**TRACT 8053 RESIDENTIAL SUBDIVISION PROJECT**

# **2014 UPDATED ADDENDA**

## FURTHER RESPONSE TO COMMENTS ON AND MODIFICATIONS TO PROPOSED PROCTOR COURT PROJECT:

MEMORANDUM: Summary of Adjustments to the Proctor Court Subdivision Project to Allow 18 Lots and an Evaluation of the Continued Standing of the INITIAL STUDY & MITIGATED NEGATIVE DECLARATION Prepared for the Previous 19 Lot Plan, As Well As Further Response to Public Comments, Technical Reports and Regulatory Requirements Subsequent to the July 8, 2013 MAC meeting.

**PROCTOR ROAD-18 LOT SUBDIVISION**  
**SITE DEVELOPMENT PLAN /**  
**PLANNED DEVELOPMENT EXHIBIT**

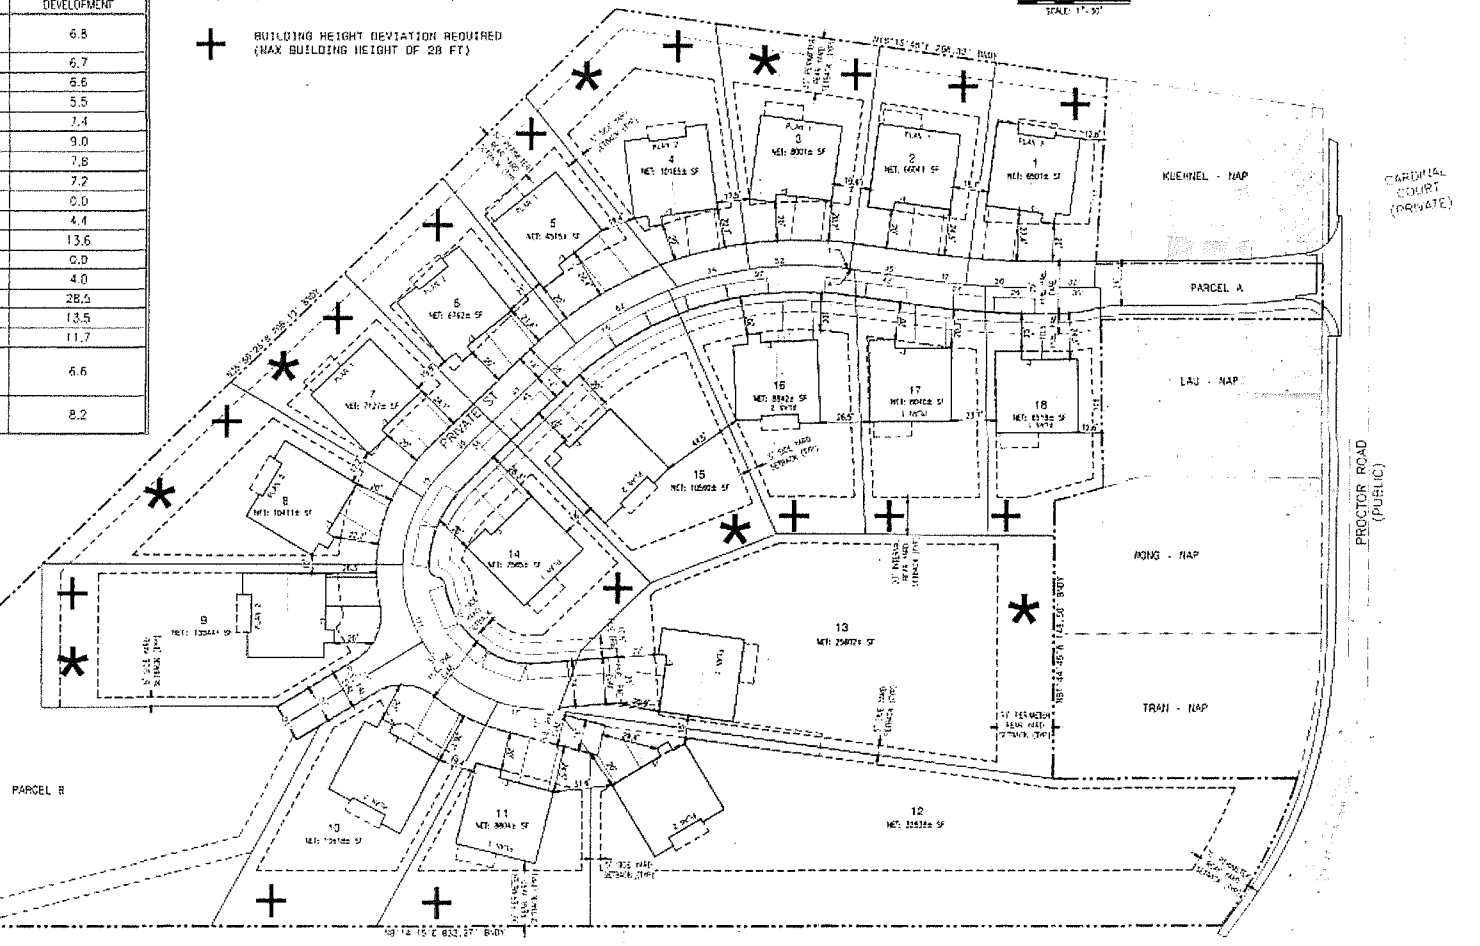
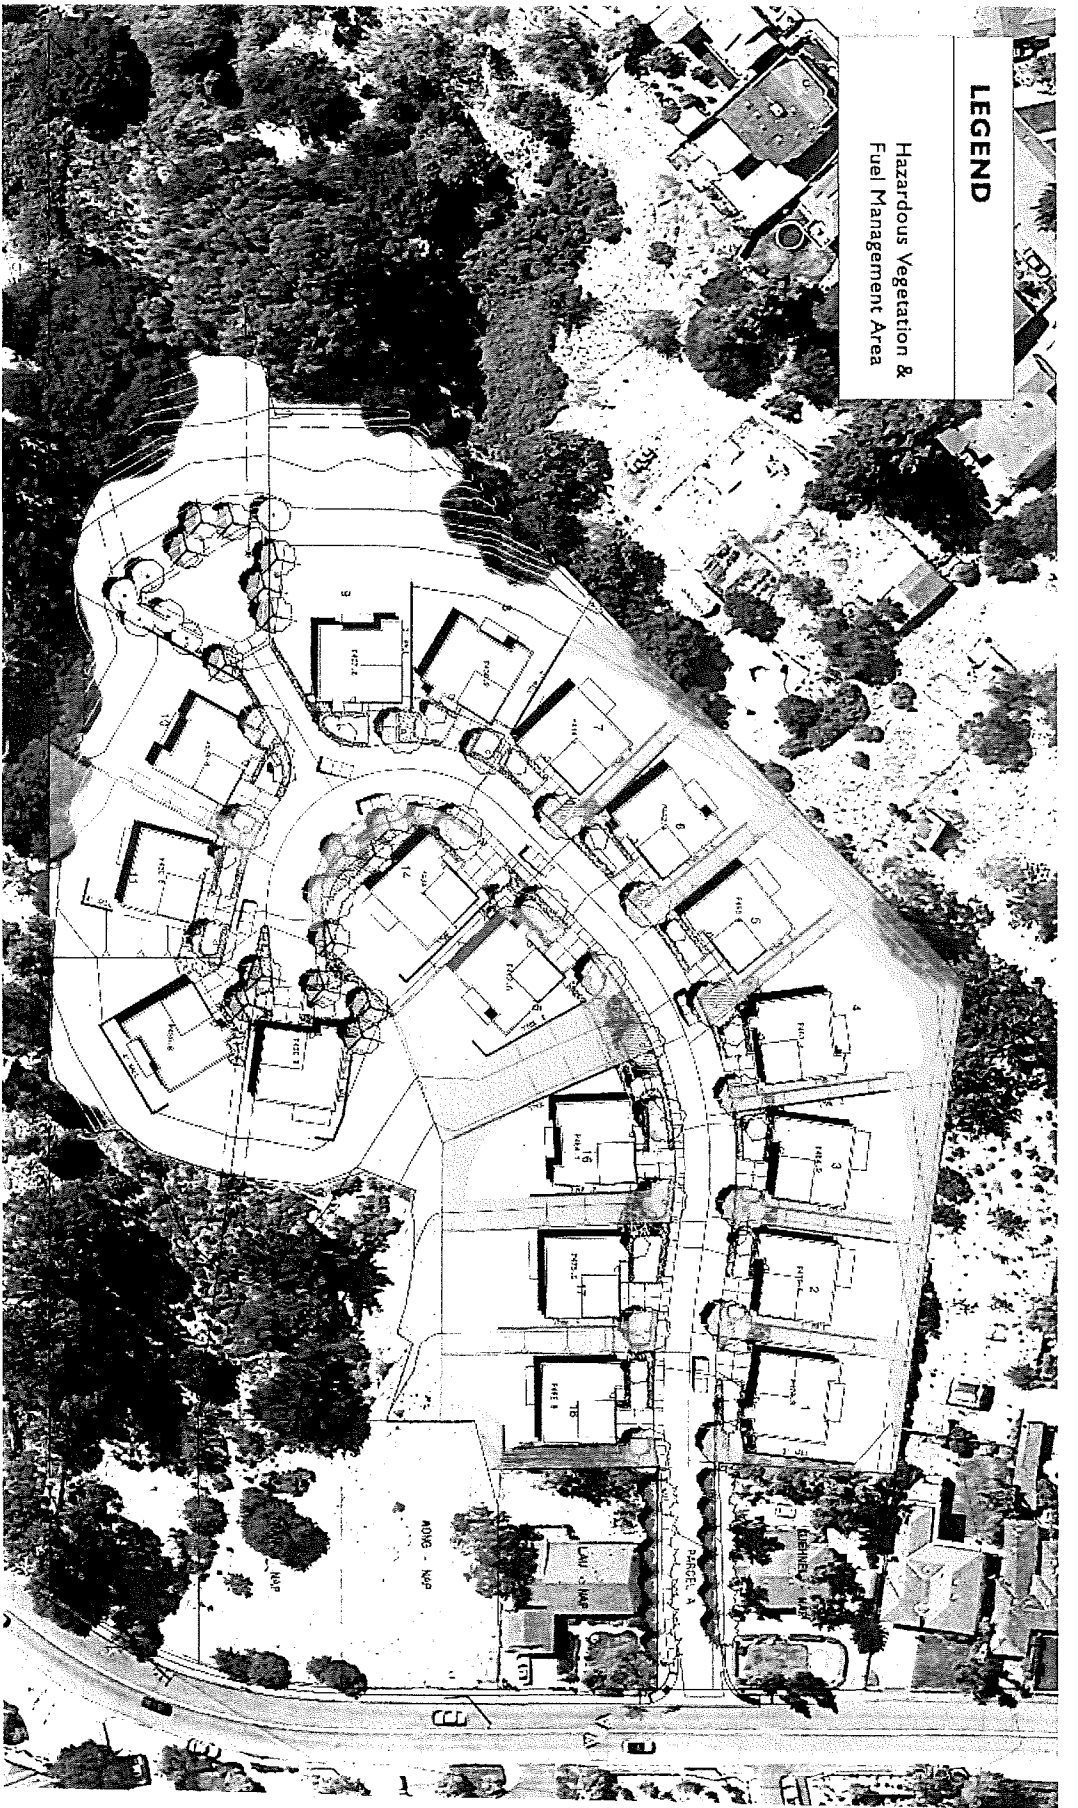
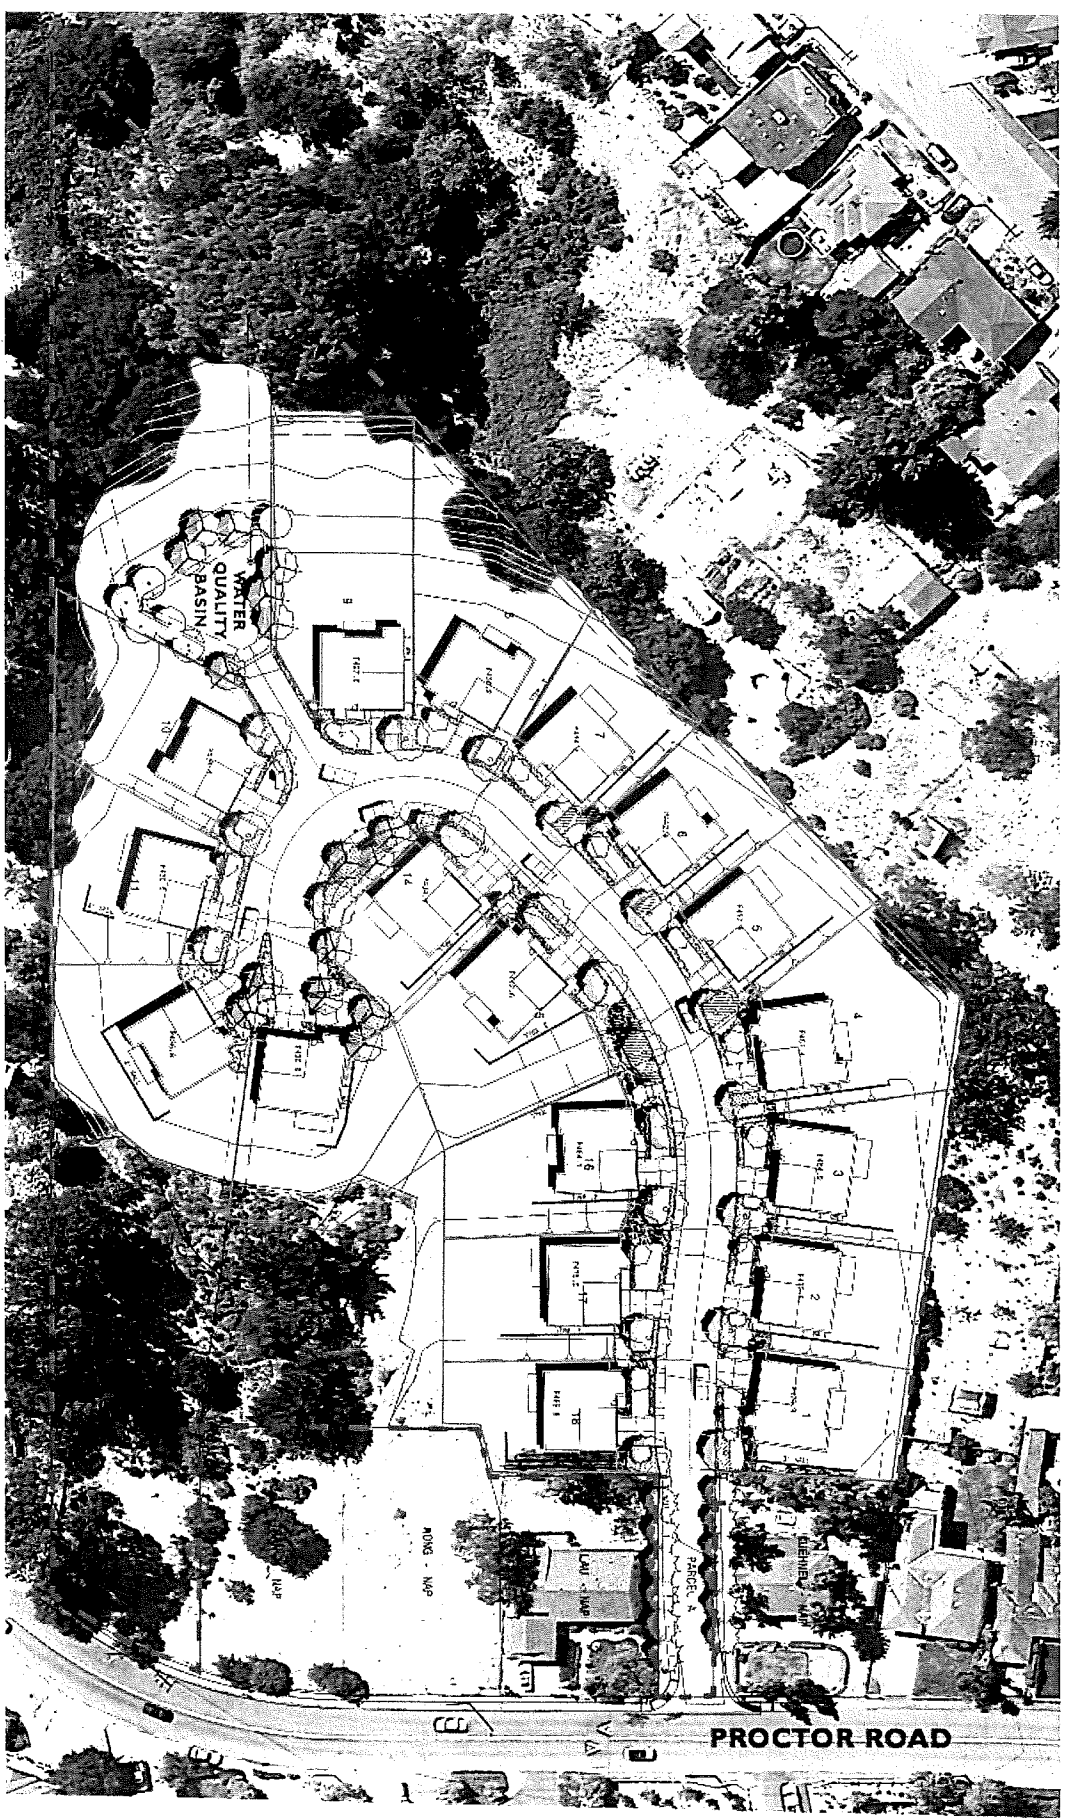
The site is located within an area designated as a very high hazard fire danger zone. The development plans now reference the former fire buffer zone on the 19 Lot plan set as a “hazardous vegetation and fuel management area” to comply with the language of the California Fire Code. The vegetation management areas are consistent with the revised lot design and do not extend into the adjacent lot on Proctor Road adjacent to Lot 1.

As has been discussed in the section above on grading, the preferred property line locations are responsive to slope and grading conditions. In a number of cases, lot lines do not maintain County standards for side yards. However, in the proposed plan the physical separation between the identified building pads for the subdivision allow or exceed the County dimension established by the standard side yard requirement. Comparably, the height of the homes proposed for the proposed flat building pads is appropriate to the sloped conditions of the site, but exceed that allowed by the standard measurement practice. The building height as it impacts the surrounding neighborhoods and adjacent lots considering the general topography and planned regrading is consistent with General Plan policies. The PD R-1 rezoning allows the necessary regulatory flexibility for full consistency of the proposed 18 Lot plan with the CVGP.

**SECTION A-A**  
**SCALE: 1" = 20' - 0"**

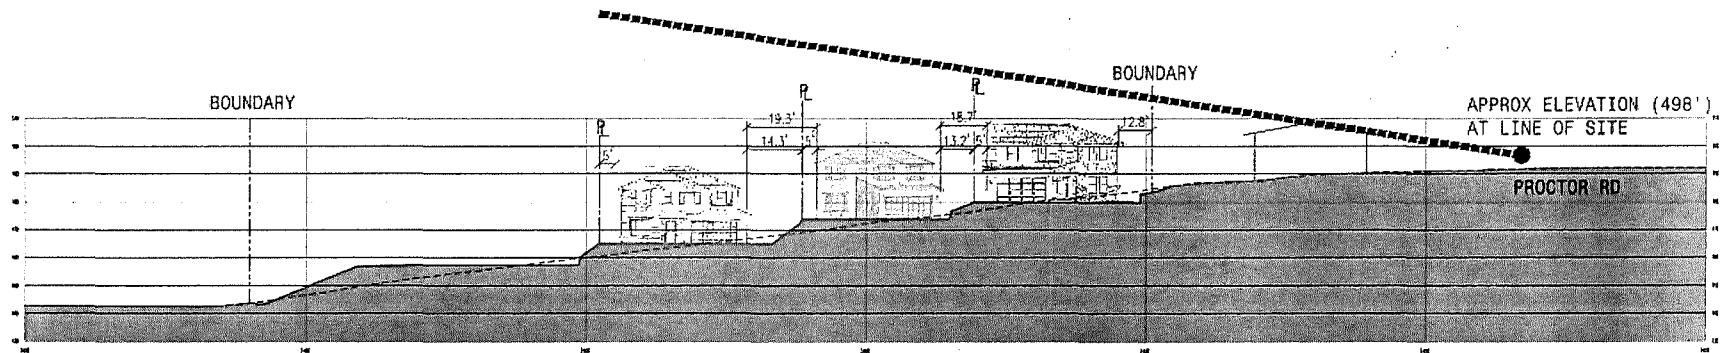
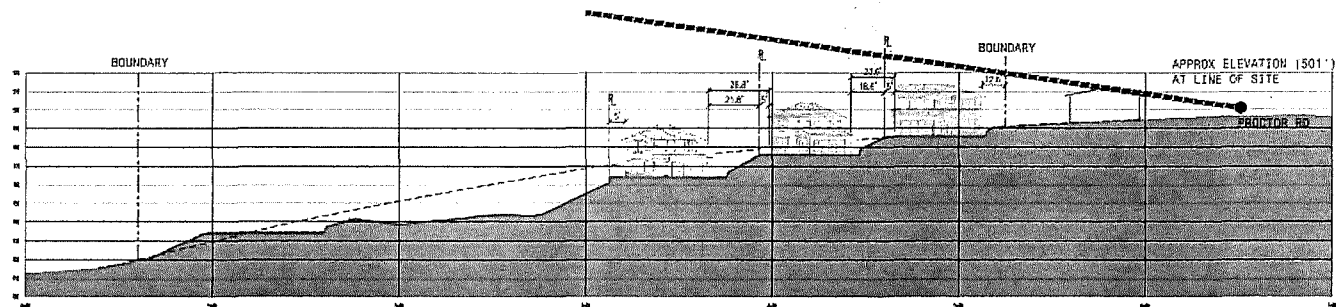
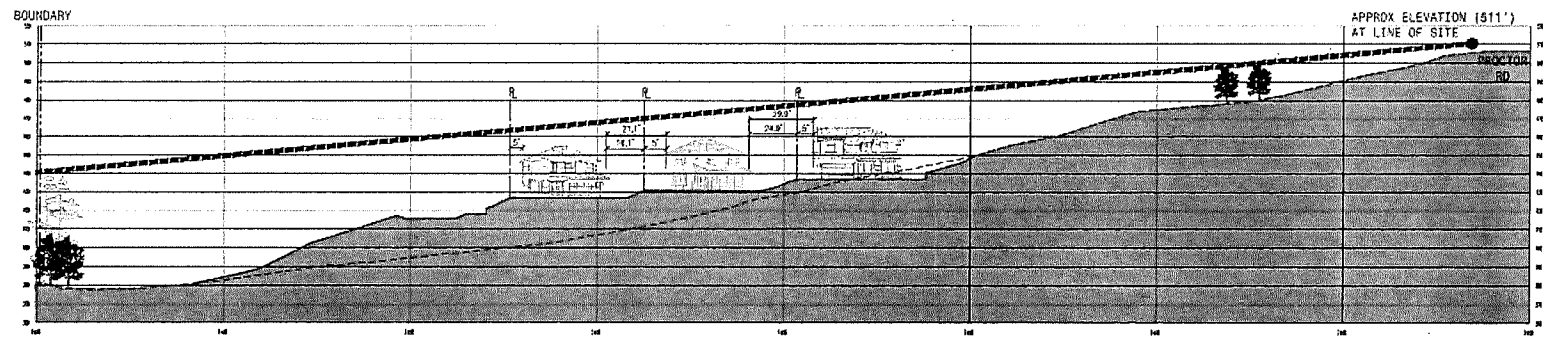
As illustrated in the plan set for the revised 18 Lot subdivision proposal (See the page titled: Cross Section View Diagrams and Analysis), future homes on the project site would either not break the height of the existing ridgeline or would be blocked from offsite views due to existing vegetation. In either case, the diagrams show that future homes on the project site would not affect views to and through the site from off site locations mainly due to fact that most homes in the new subdivision will be constructed at a lower elevation in comparison with the homes in the surrounding area. Views for adjacent residents remain relatively unaffected by the 18 Lot.

The viewshed analysis included in the plan set demonstrates the extent to which the modified site grading and flat building pads increase the protection of views across the subdivision, including conformance with the policy intent of the Castro Valley General Plan (CVGP). As discussed in section 8 below, the proposed 18 Lot subdivision will require rezoning to a PD district allowing R-1 uses.
